Noncompliant Weld Inspection Techniques

Line 114 Non Destructive Examination Final Report

Issue Date December 5, 2013

Figure 2 – Weld 270 Indication with measurement inset showing length of 0.157” (3.9mm)

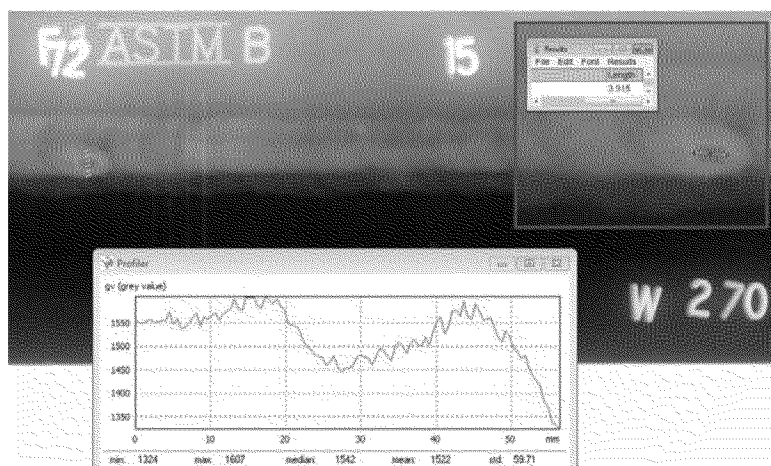
- 3.1 Weld 270, digitized in the region of interest is depicted in Figure 2. Here it can be seen, due to low change in density which is less than the adjacent parent material, and the presence of a halo, that the indication is one of Burn-Through (BT), and is acceptable per section 9.3.7 of API-1104. The weld repair process confirmed this result where the indication was found at the root.

Figure 3 – Weld 311 with acceptable BT length of 0.141” and acceptable small pores

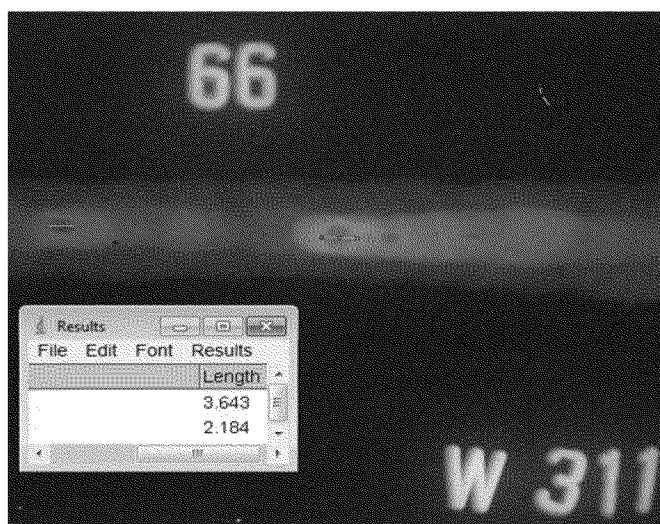
3.2 Weld 311, digitized in the region of interest, is depicted in Figure 3. Similarly we have one indication of burn-through and 3 small pores, all of which are acceptable per sections 9.3.7 & 9.3.9 of API 1104. For both welds 270 and 311, the repair process had to proceed to the root before the indications were eliminated, confirming that they were caused by burn through.

Figure 4 – Weld 162 with acceptable indications of undercut

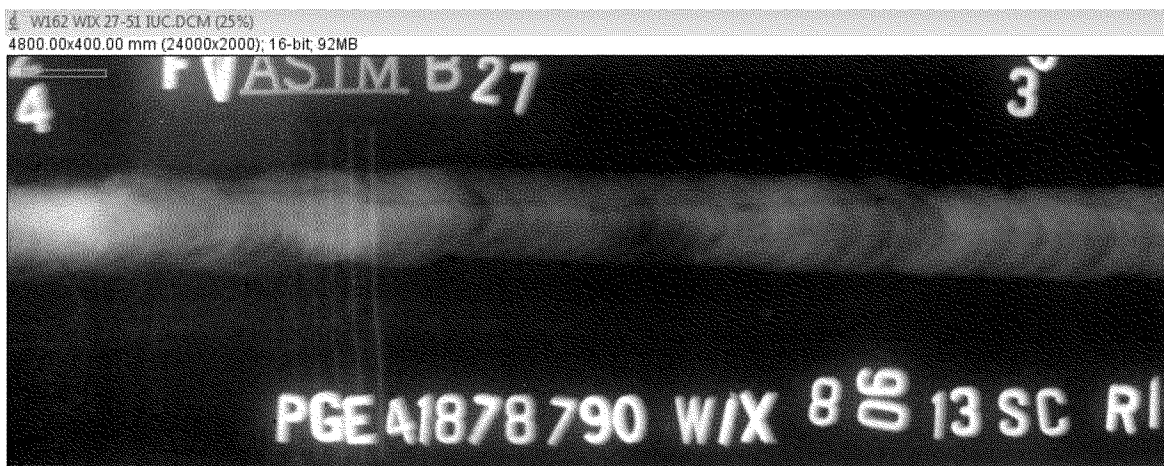
3.3 Weld 162 indication was digitized as shown below in Figure 4. Radiographic density measurements indicate that no portion of the indication has an indication of undercut which is greater than 0.016” deep, indicating that it is acceptable per section 9.3.11& 9.3.7 of API 1104.

Figure 5 – Measured IUC on W162 depicted in Figure 4

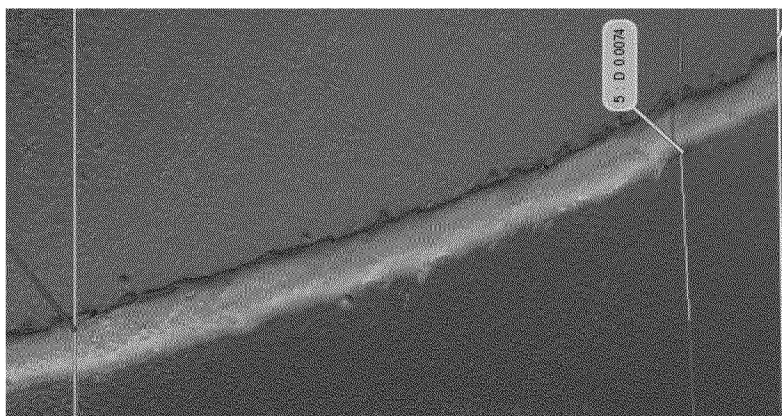
- 3.4 To validate the digital radiographic measurements, external visual, UC gaging and dial indicator measurements revealed that only small areas within the called ROI (25-29) had bottoms estimated below the adjacent parent material surface. Measurements had thus low repeatability due to topography. This result led to the decision for the Creaform photogrammetry with its calibrated 40 micron spatial resolution and accuracy to within 0.002”.
- 3.5 Creaform photogrammetry results were obtained for the radiographic ROI (25-29 in Figure 4). The measurements confirm that no portion of the indicated area of concern radiographically, has a depth greater than 0.016 inches, and is therefore acceptable per sections 9.3.11 & 9.7. Figure 5 below depicts worst case of 0.0074” in radiographic ROI.

Figure 1 – Assessment of Weld 760 IUC region of interest

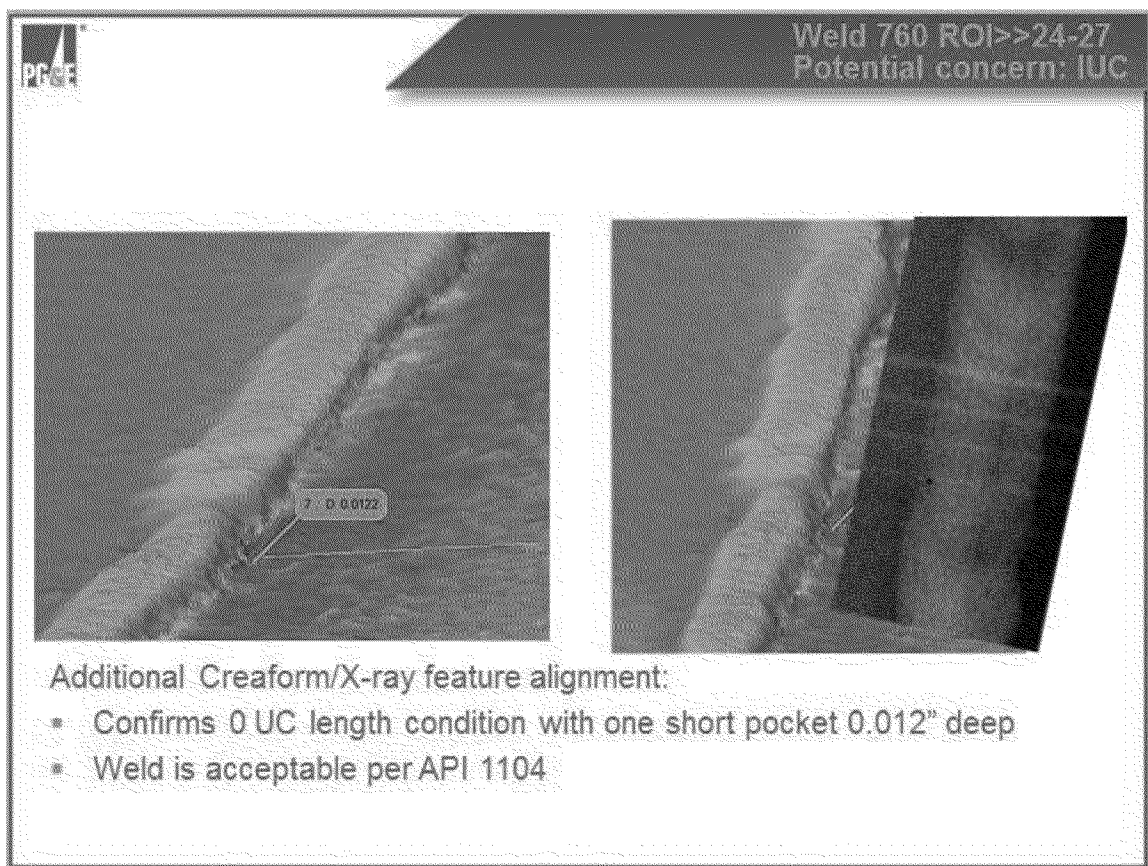
3.5 Creafom photogrammetry results were obtained for all the radiographic ROI's. The criteria applied to these results were API 1104 section 9.7, Table 4, "Maximum Dimensions of Undercutting". Applying the further criteria of depth from this requirement, to the documented radiographic and visual measurement data for length, all welds were found acceptable. Figure 2, from slide 5 in Appendix I, summarizes the typical physical condition for the audit identified indications of concern.

Weld 760 cited for indications of internal undercut from 24-27

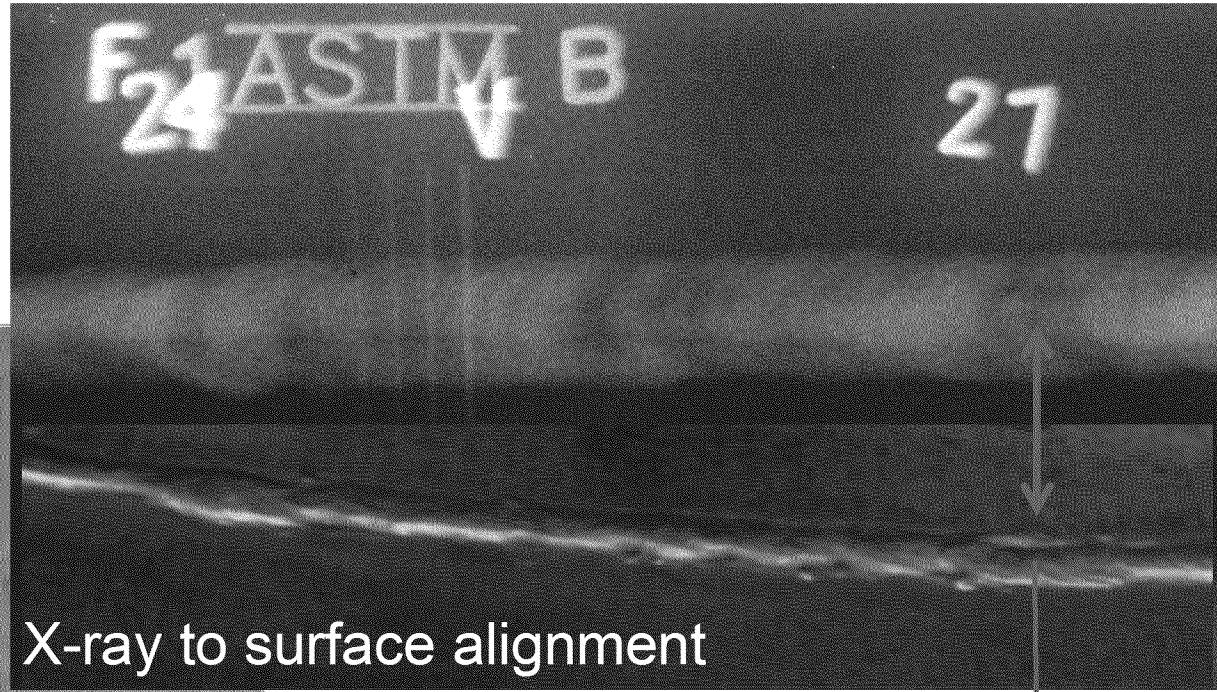
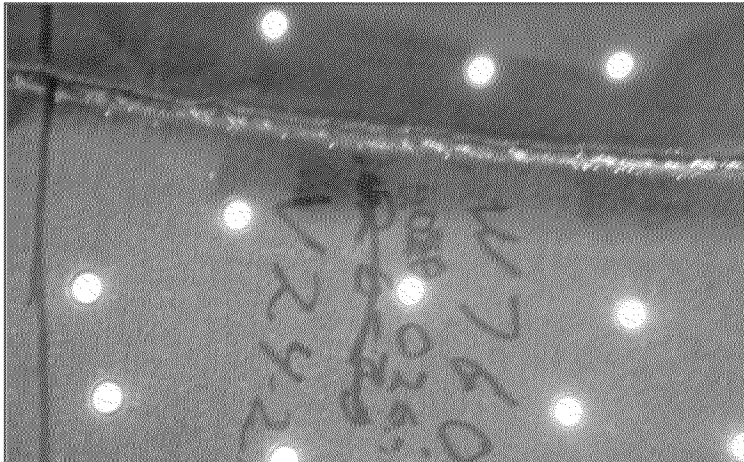
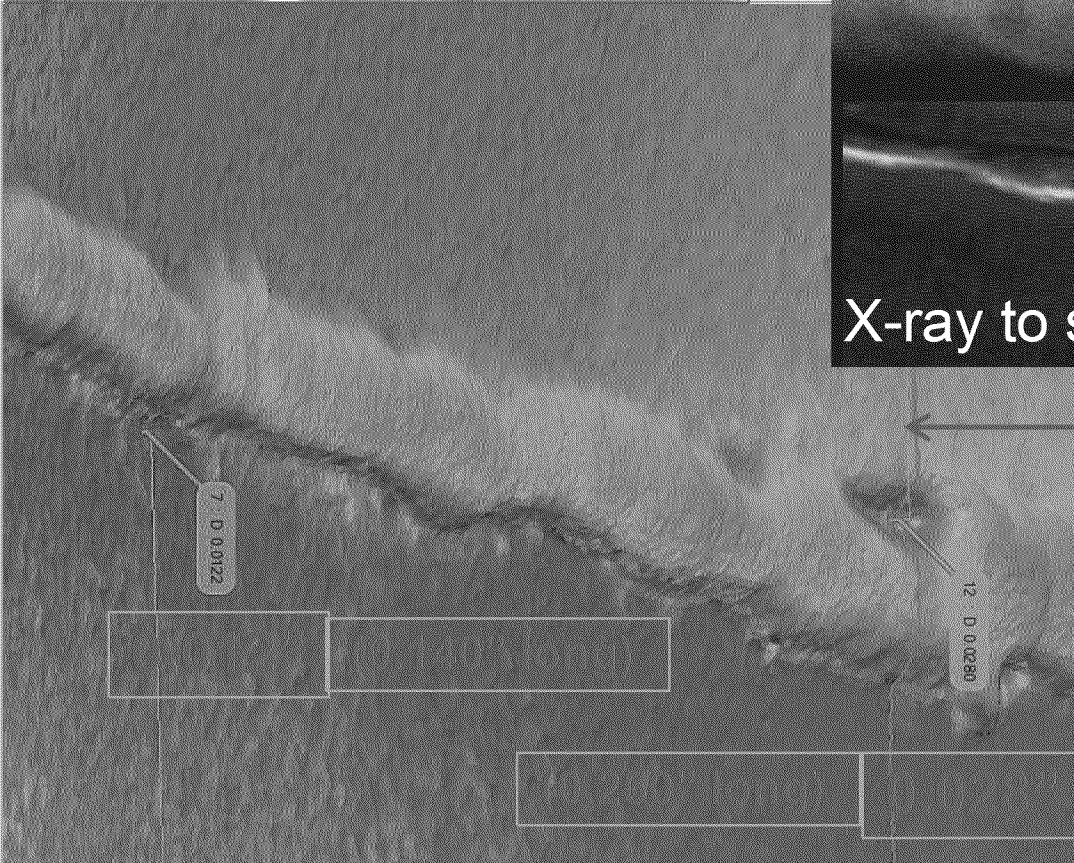
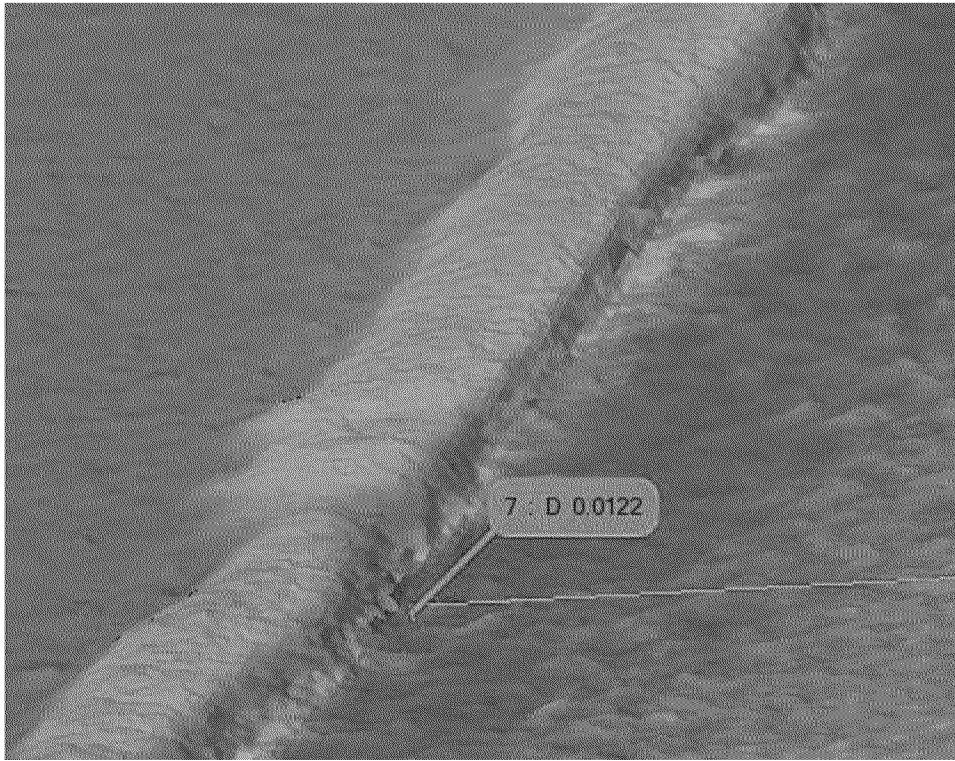
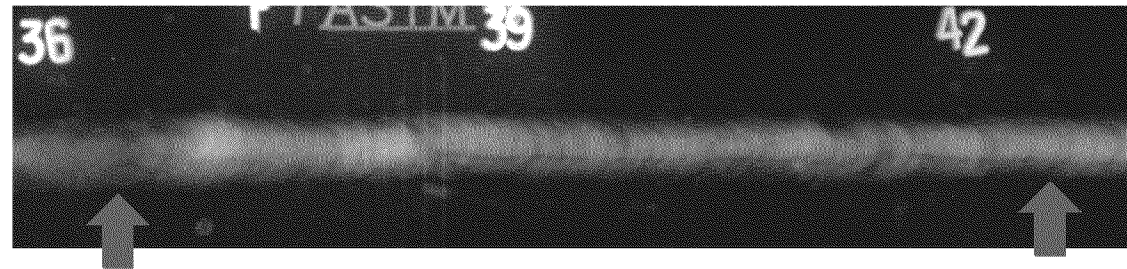
RT estimated depths of 0.012 – 0.028 inches

Confirms indications are mostly diffraction effects on minor hi/lo condition with 0 UC

Two small pockets are 12 and 28 mils deep with greatest length of 0.250"

Weld is acceptable per API 1104

Weld 770 cited for indications of internal undercut from 36-42
Excised weld photo-documented and ROI aligned with weld features
Depth of most severe indications estimated by change in x-ray density

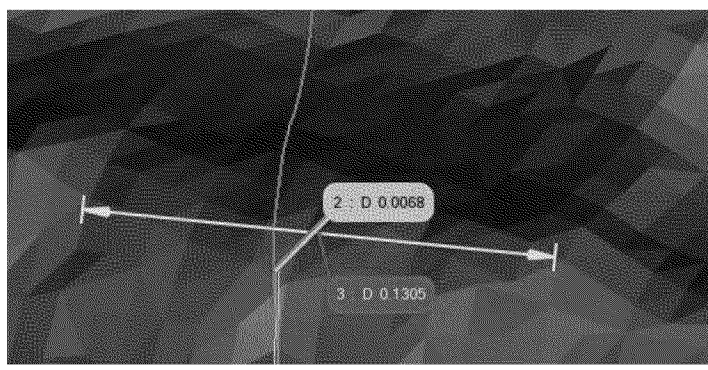
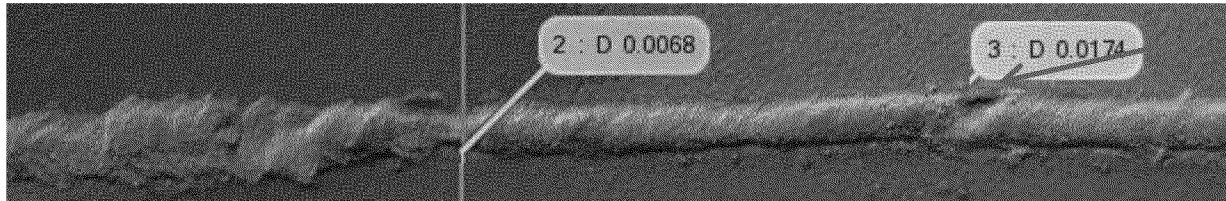
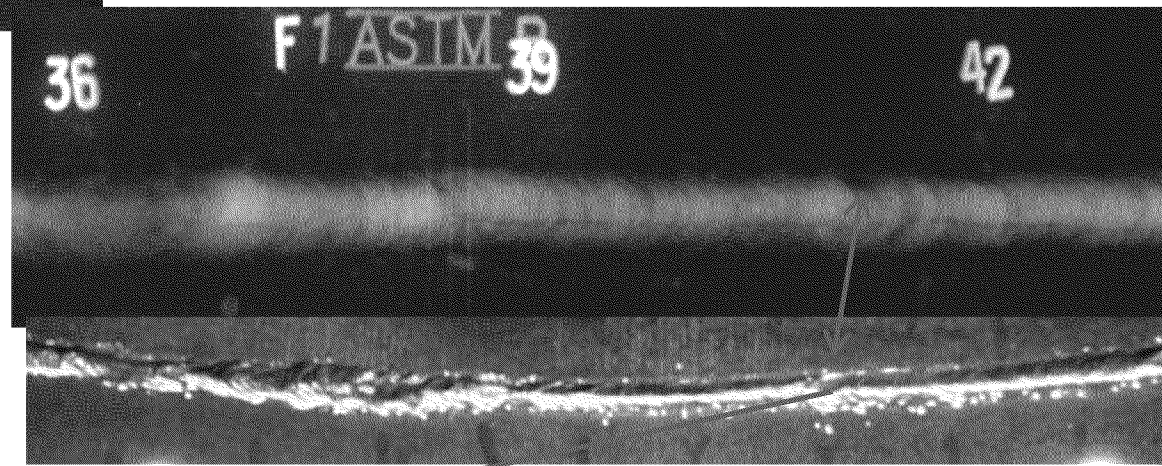
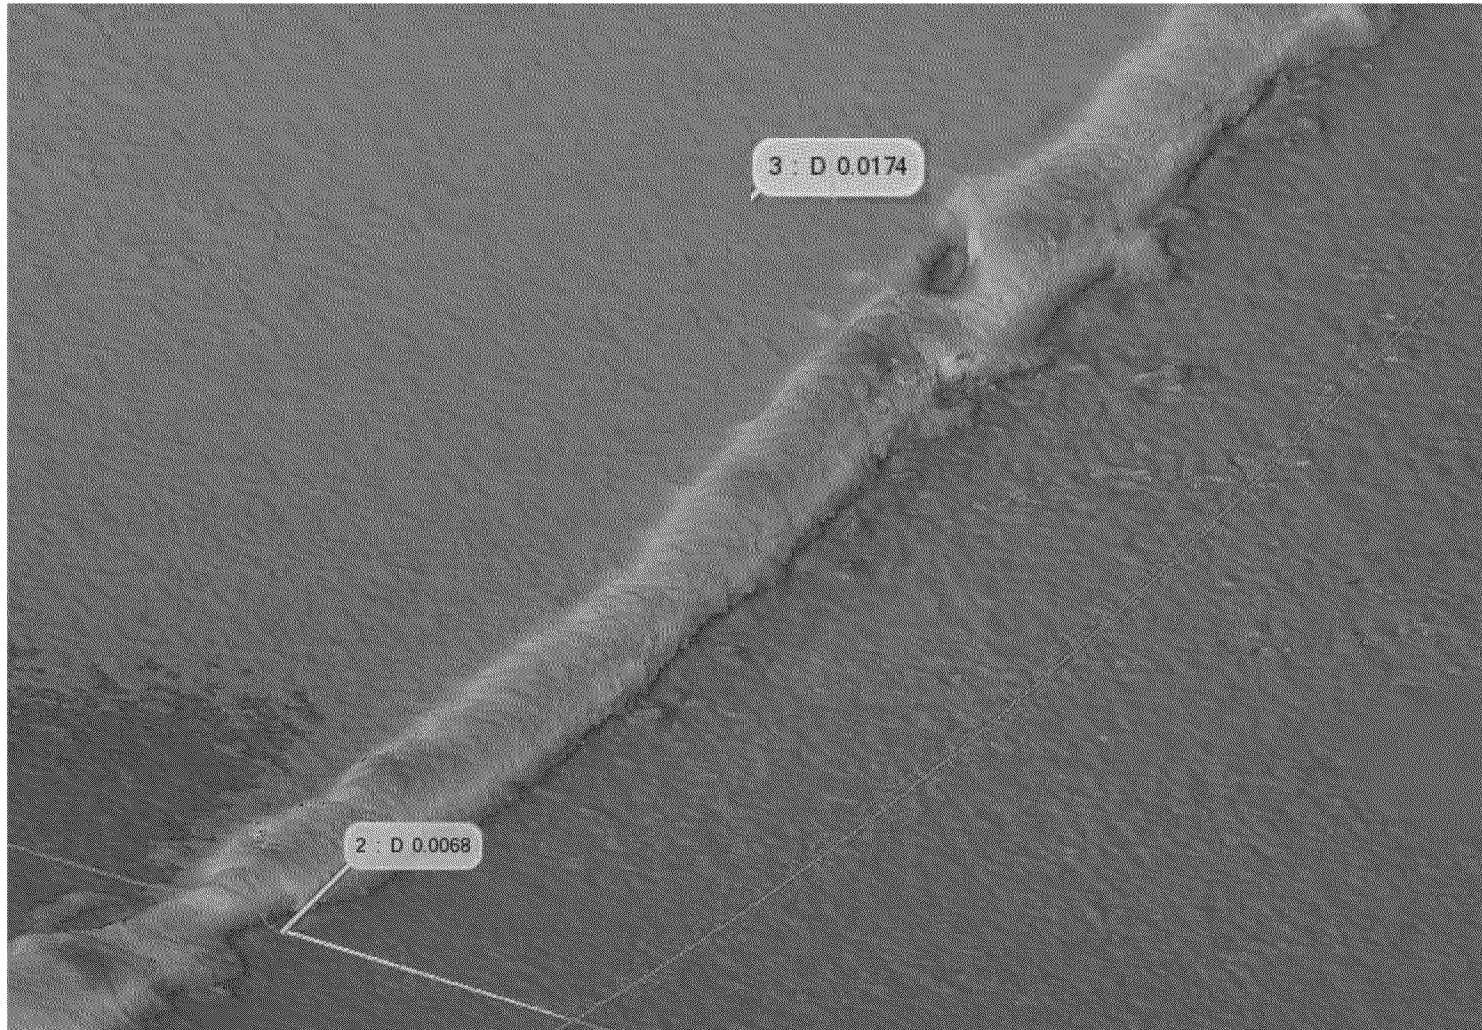
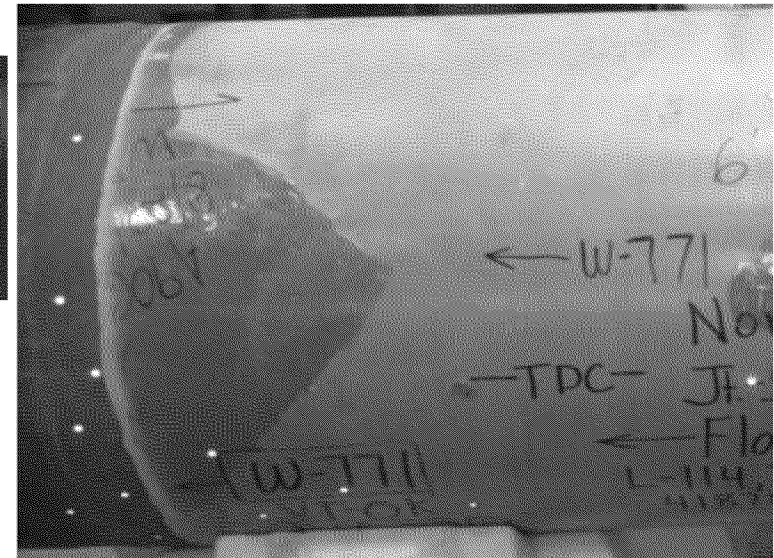
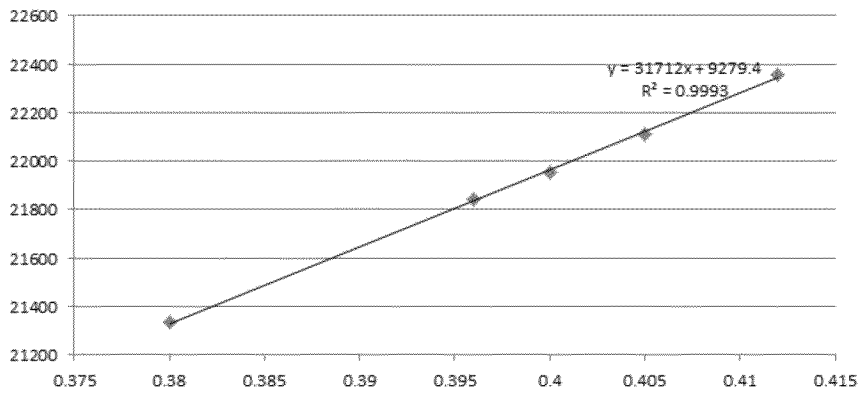
RT estimated depths of up to 0.008 inches

- Confirms indications are, in the majority, diffraction effects on minor hi/lo condition with 0 UC
- One small pocket observed at 0.007" deep x 0.130" long
- One unrelated pocket opposite ROI of 0.017" deep x 0.195" long
- Weld is acceptable per API 1104

- * Confirms UC indication is diffraction/"shadowing" from high/low condition
- * Weld is acceptable per API 1104
